Decision and reasons on Transpower's Upper South Island Reliability Stage 1 Major Capex Proposal

Date: 13 February 2013

Figure D1: Upper South Island demand forecast

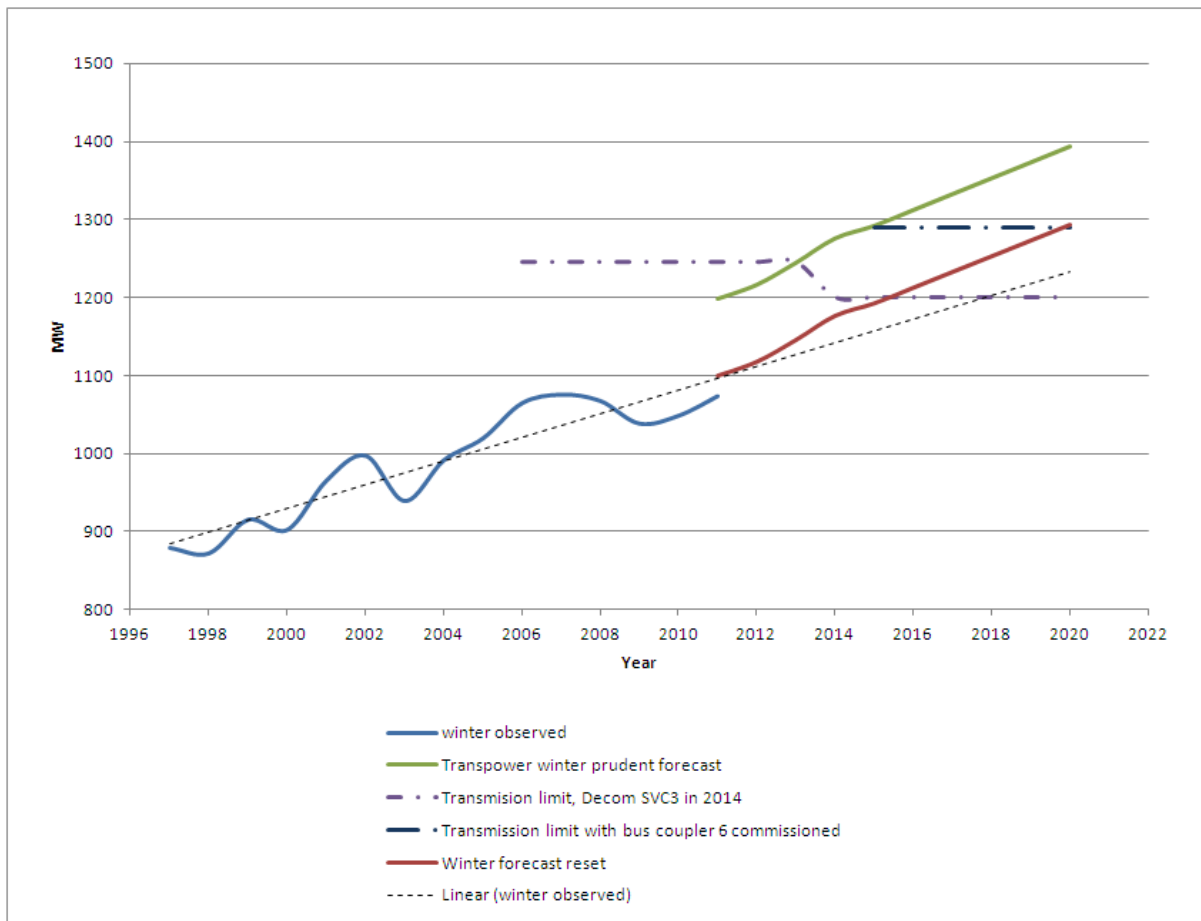
- D9 We consider that Transpower's demand forecast is optimistic because it does not allow for the decrease in demand due to the Christchurch earthquakes. Transpower has recognised this and advised us that it will monitor demand and plan investments in the USI reliability development programme accordingly. Transpower's approach seems reasonable and we consider that Transpower should be able to demonstrate that the timing for any preliminary works associated with the USI reliability development programme is optimal and takes into account all relevant factors.

- D14 Figure D1 shows our analysis of the demand forecast. The observed demand for 2011 is about 120 MW lower than Transpower's forecast demand ('Transpower winter prudent forecast' in Figure D1), indicating that demand forecast is over estimated by 120 MW. To get a more realistic demand forecast based on current observed demand, we reset the 'Transpower winter prudent forecast curve' to the 'winter observed trend line'. This line represents the linear trend of the currently observed demand. The reset curve, referred to as 'Winter forecast reset' in Figure D1, shows that peak demand may not reach the 'transmission limit with bus coupler 6 commissioned' until about 2020.⁷⁹
